**Amendments to the Drawings:**

**REMARKS**

The Final Office Action mailed March 2, 2004, has been received and reviewed. Claims 1, 3, 4, and 18 through 26 are currently pending in the application. Claims 1, 3, 4, and 18 through 26 stand rejected. Applicants propose to amend claims 1, 3, 4, 20, 22, 23 and 25, and respectfully request reconsideration of the application as proposed to be amended herein.

**Fig. 2**

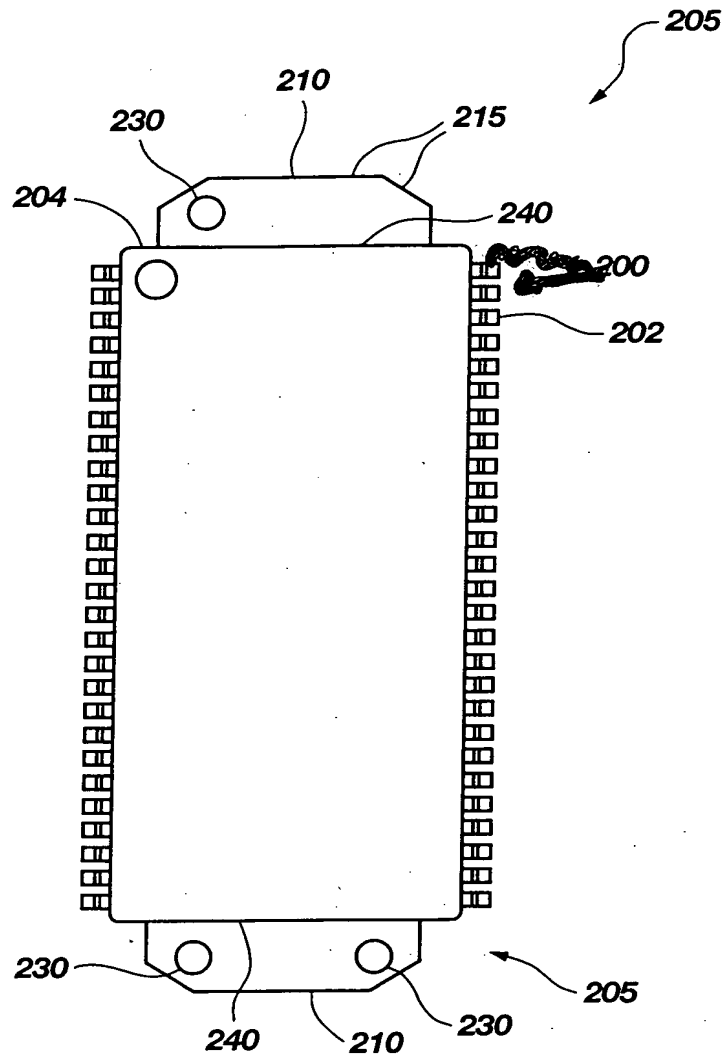
The Examiner objects to the drawings as failing to comply with 37 CFR 1.84(p)(5) because FIG. 2 does not include the reference sign "200." Applicants note that FIG. 2 *does* include the reference sign "200" and, that, in a previously submitted Amendment Applicants amended the lead line associated therewith for purposes of clarity.

Applicants submit, herewith, replacement FIGS. 2, 4A and 4B which incorporate drawing changes already submitted (see Amendments mailed on May 3, 2003, and November 17, 2003 – copies of previously submitted FIGS. 2 and 4A and 4B showing changes marked in red are also included herewith for the convenience of the Examiner).
